STREET A PLAN AND
PROFILE

PARKER RIDGE
82 SCHOOL STREET
ROLESVILLE / NORTH CAROLINA / 27571

08/01/2023 PER TOWN OF ROLESVILLE COMMENT

LENNAR
CORPORAION
1100 PERIMETER PARK DRIVE, SUITE 112
MORRISVILLE / NORTH CAROLINA 27560

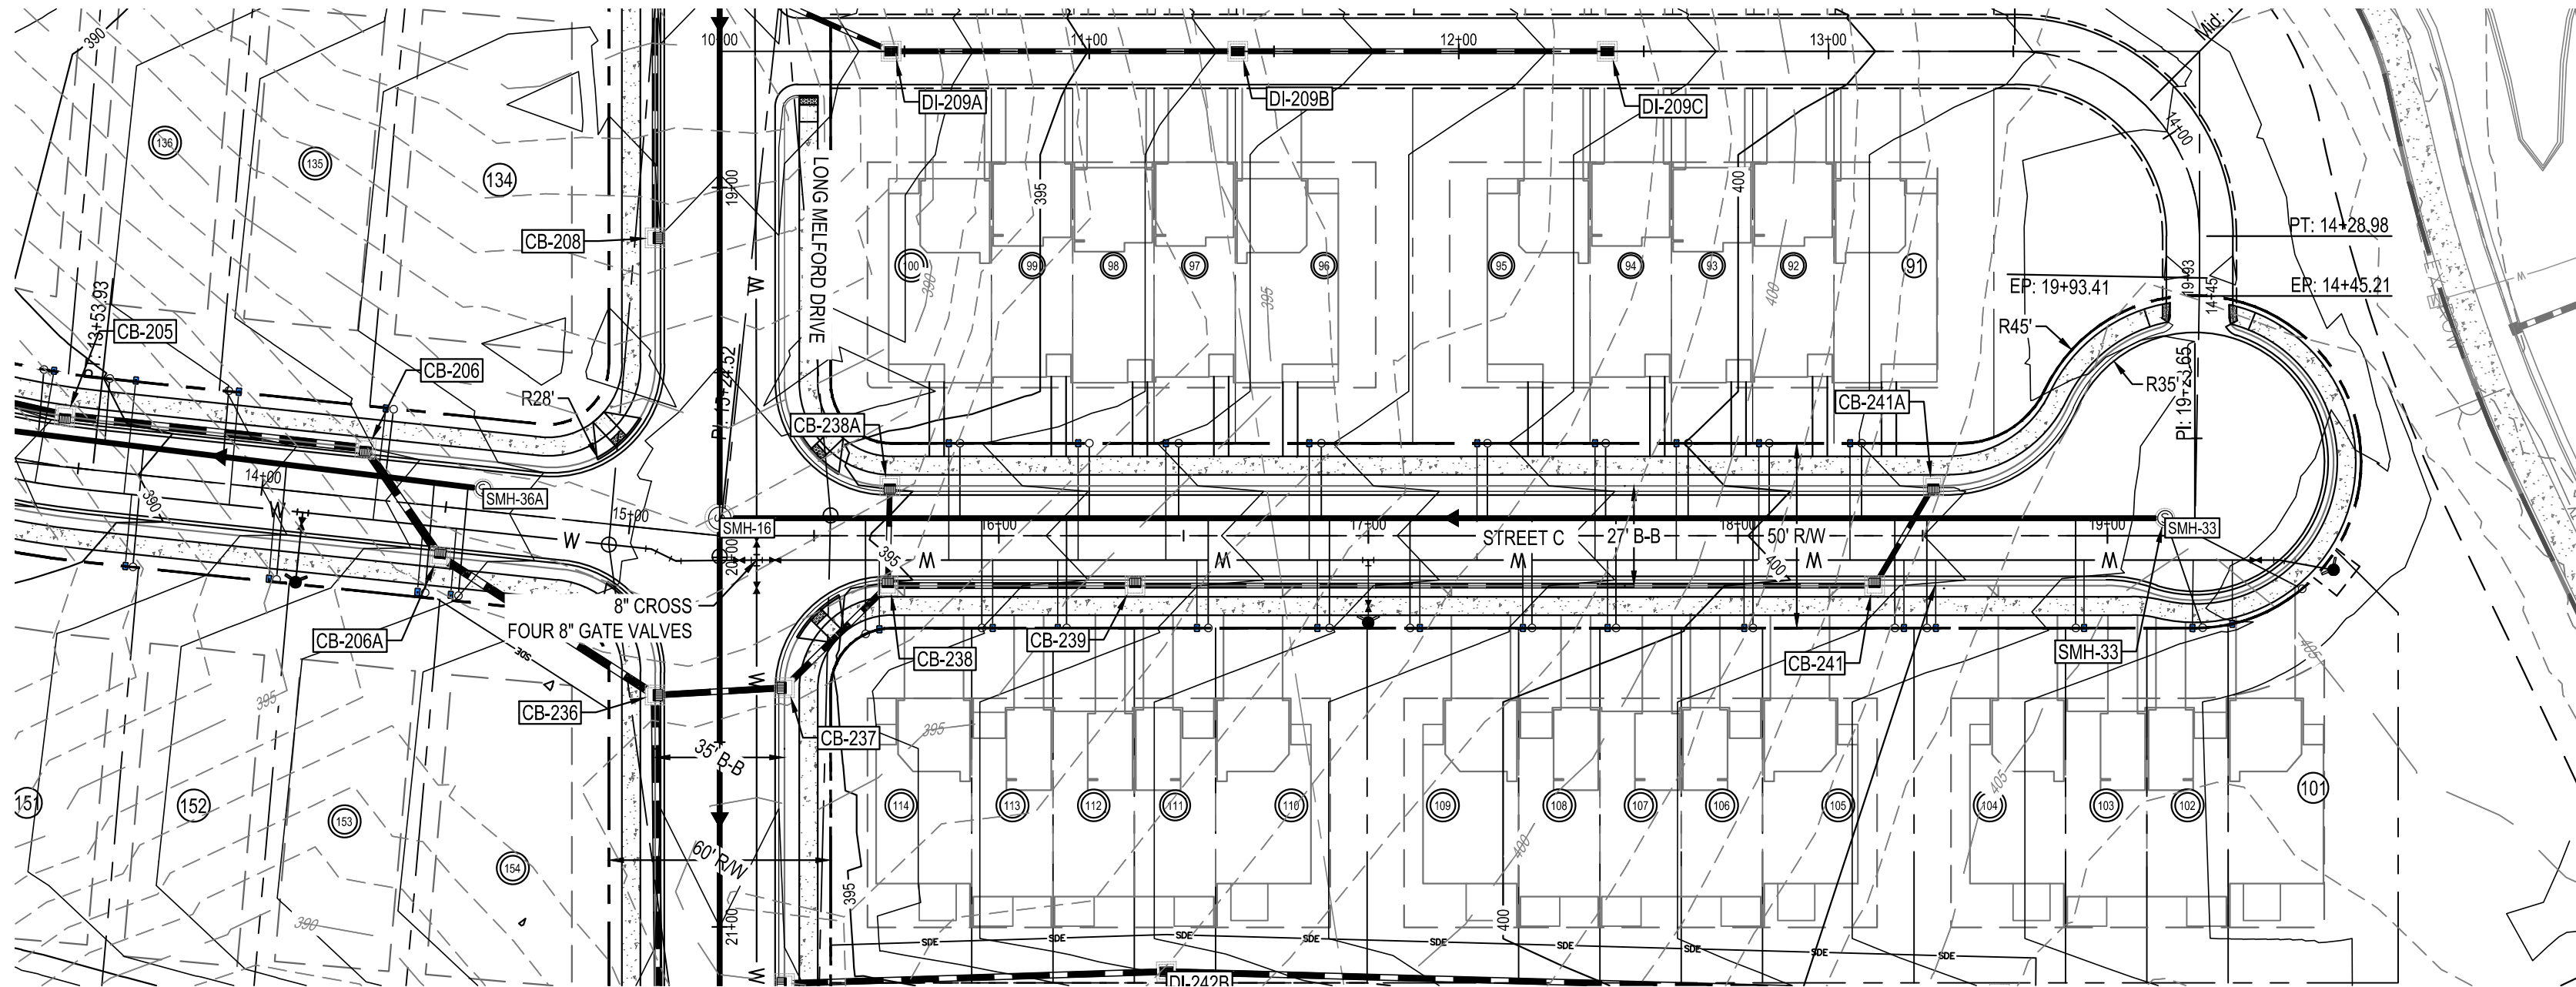
#69- If vertical bends are to be used, please label them.

#68- The waterline should be bent below the storm crossing, which is between CB-206 and CB-206A. Adjust waterline so minimum cover is provided.

#63- Waterline does not match the other Street C profile

#62- There are several locations where the dimensions don't seem to line up with top/bottom of pipes. Please make sure it is clear what is being dimensioned. If crossings are not meeting minimum requirements, design will need to be adjusted.

#63- Waterline does not match the other Street C profile

STREET D PLAN AND
PROFILE

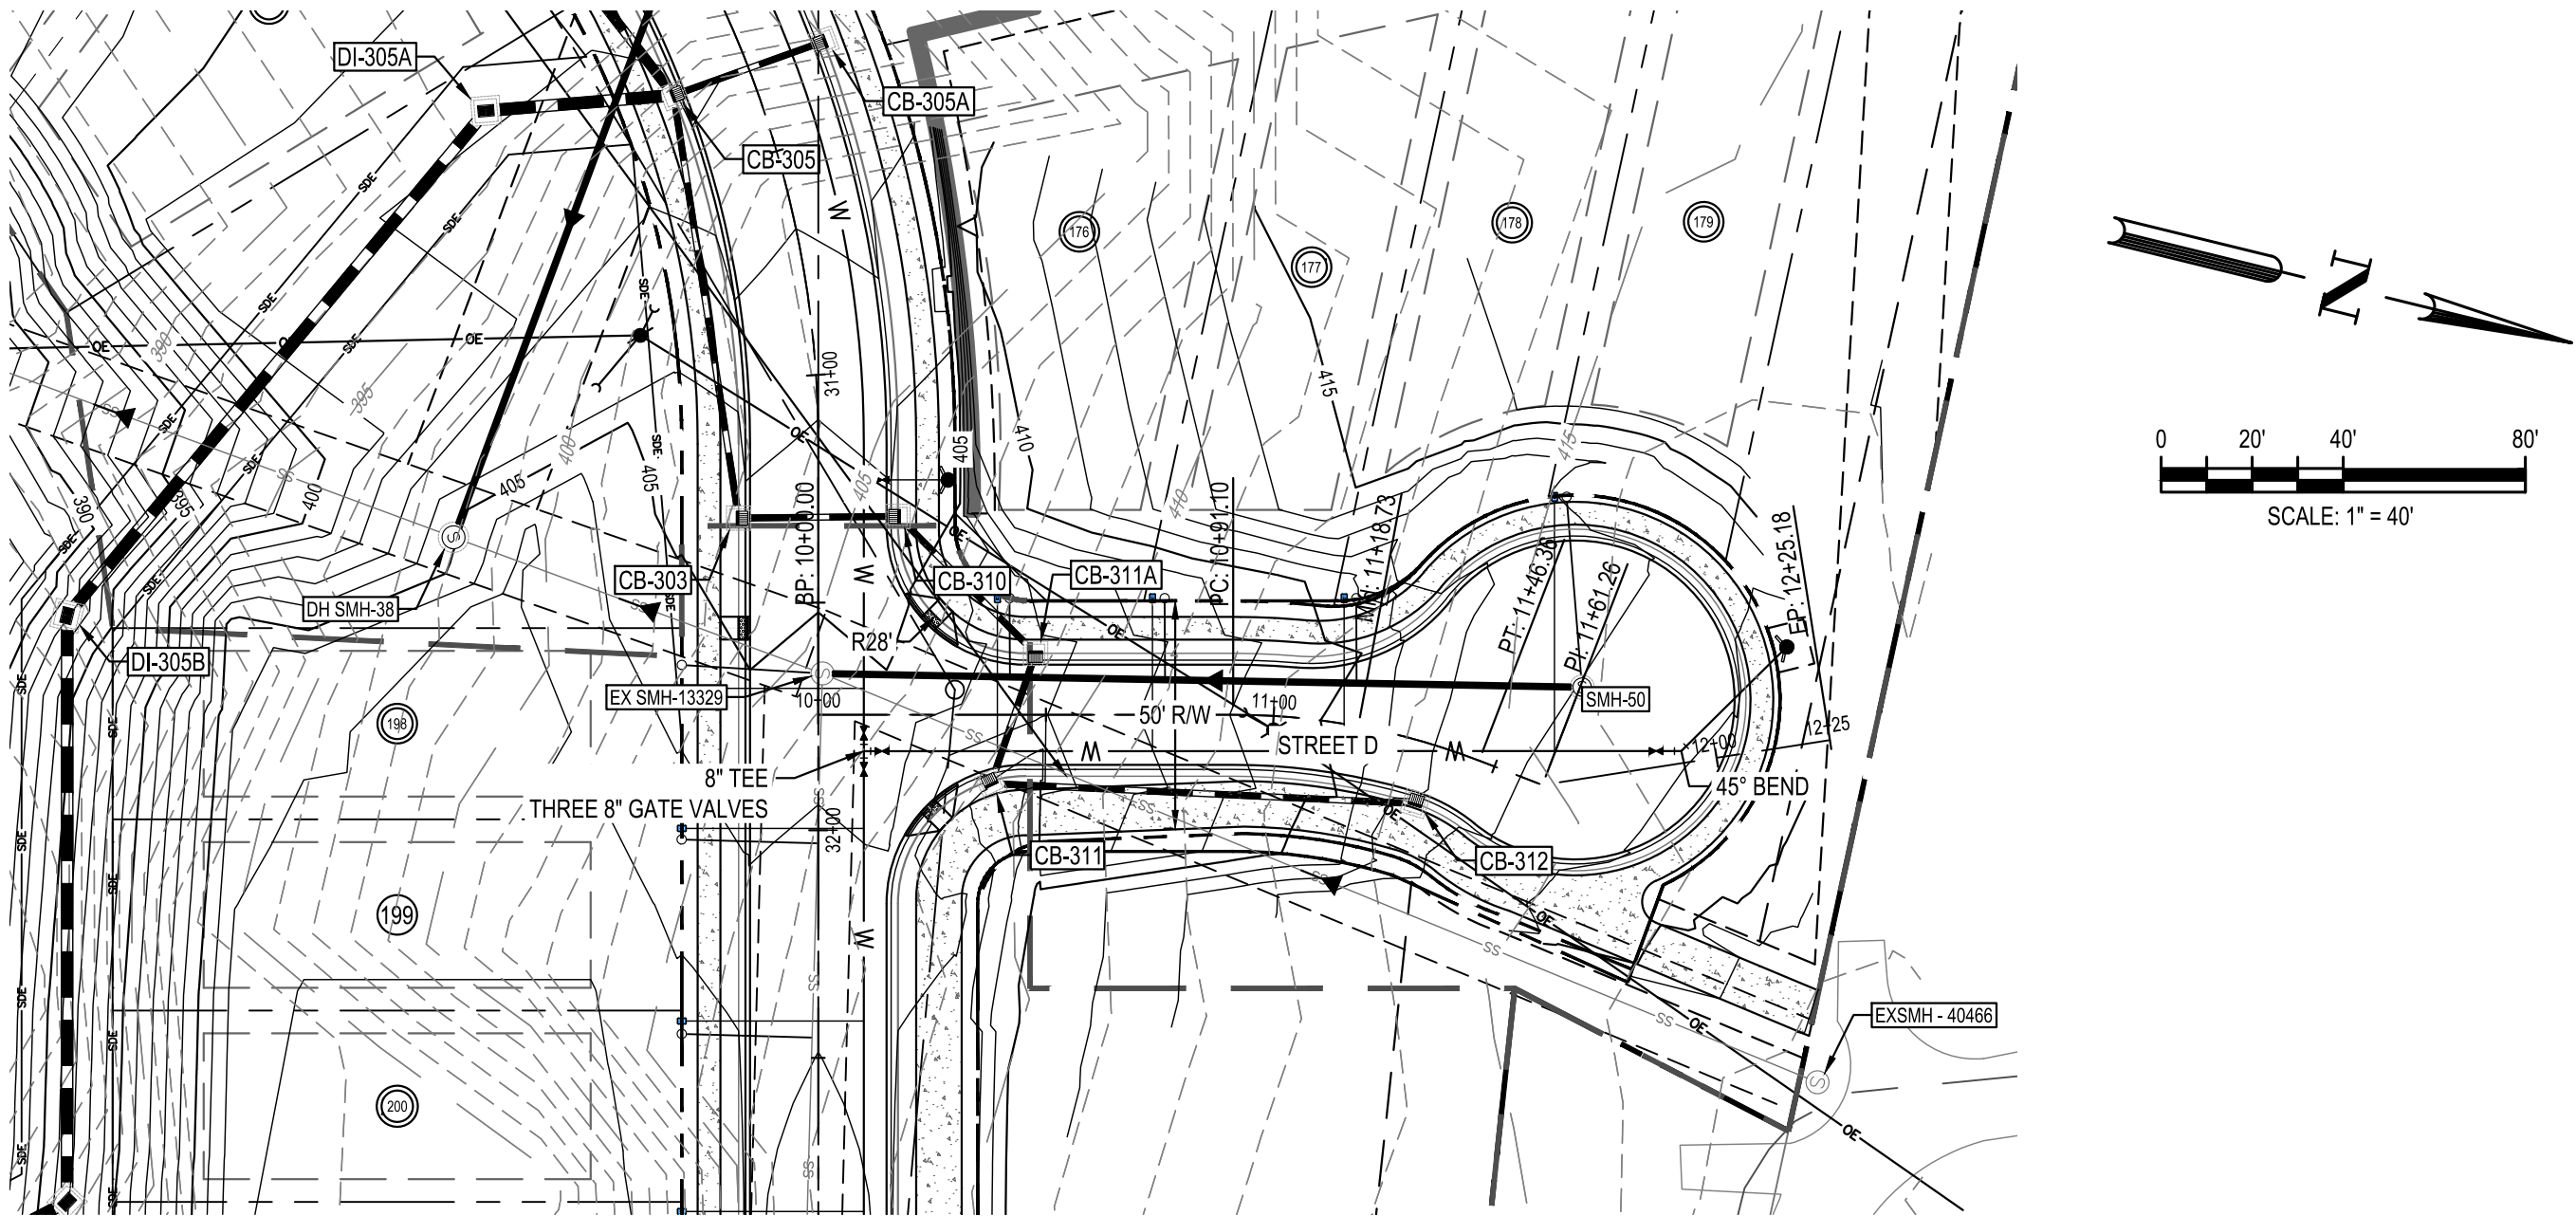
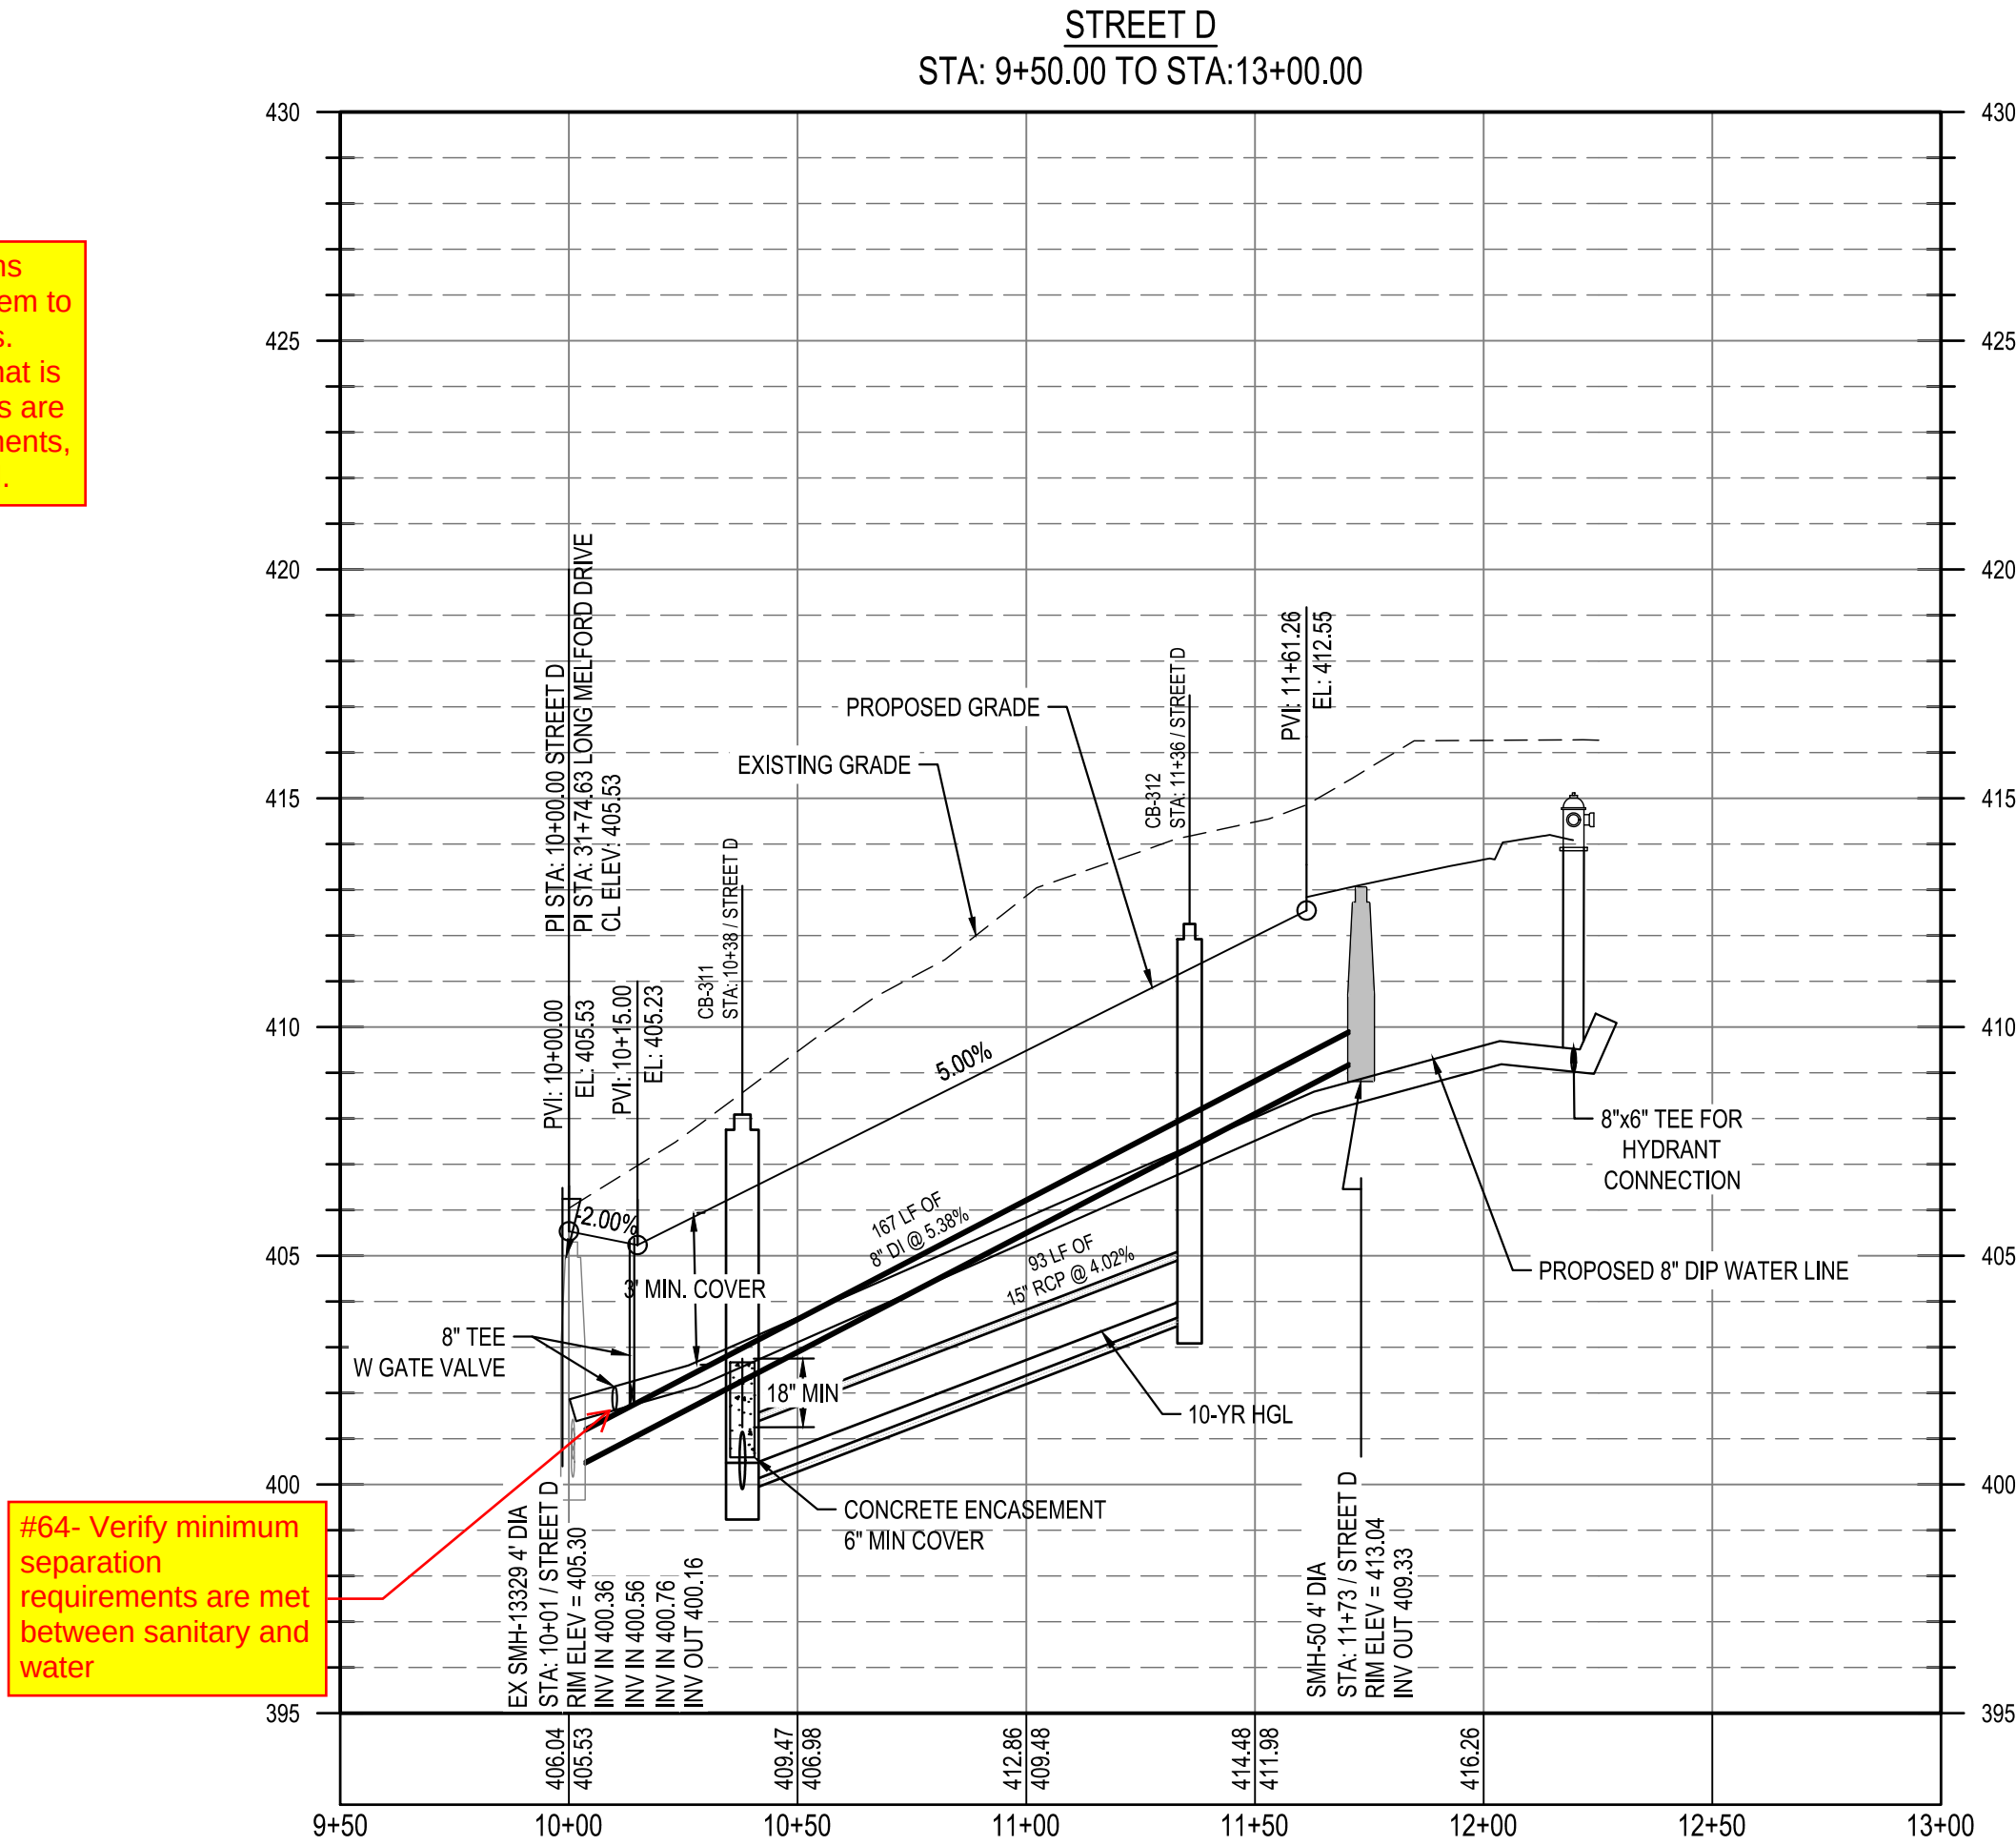
#62- There are several locations where the dimensions don't seem to line up with top/bottom of pipes. Please make sure it is clear what is being dimensioned. If crossings are not meeting minimum requirements, design will need to be adjusted.

#64- Verify minimum separation requirements are met between sanitary and water

#62- There are several locations where the dimensions don't seem to line up with top/bottom of pipes. Please make sure it is clear what is being dimensioned. If crossings are not meeting minimum requirements, design will need to be adjusted.
